UNITED STATES PATENT AND TRADEMARK OFFICE

Office Action Summary

10/551,763

DETAILED ACTION

FIG.2B

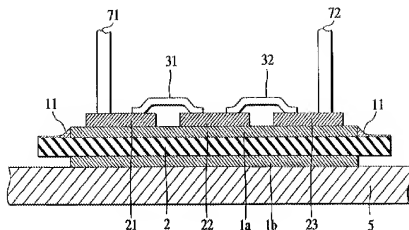
a first electrically insulating material **11** disposed in a corner region formed by said first electrically conductive layer **1a** and said peripheral region of said electrically insulating substrate **2** ((see col. 12, lines 49-58 and FIG. 2A) and (col. 12, line 63 to col. 13, line 12 and FIG. 2B));

the surface of the first electrically insulating material **11** disposed in the corner region formed by said first electrically conductive layer **1a** and said peripheral region of said electrically insulating substrate **2** is concave-shaped (see col. 12, line 63 to col. 13, line 12 and FIG. 2B, for example),

wherein the first electrically insulating material **11** fills gaps in a junction between the first electrically conductive layer **1a** and the electrically insulating substrate **2** (see col. 12, lines 49-63 and FIG. 2A).

However, Shimizu et al. is silent about wherein the first electrically insulating material is a polyimide.

As Nidan et al. disclosed, one of ordinary skill in the art would have been motivated to substitute polyimide resin for epoxy resin because epoxy resin and polyimide are interchangeable. As known to one of ordinary skill in the art, thermosetting resin such as epoxy or polyester resin serve similar purpose as a thermoplastic resin such as polyimide resin.
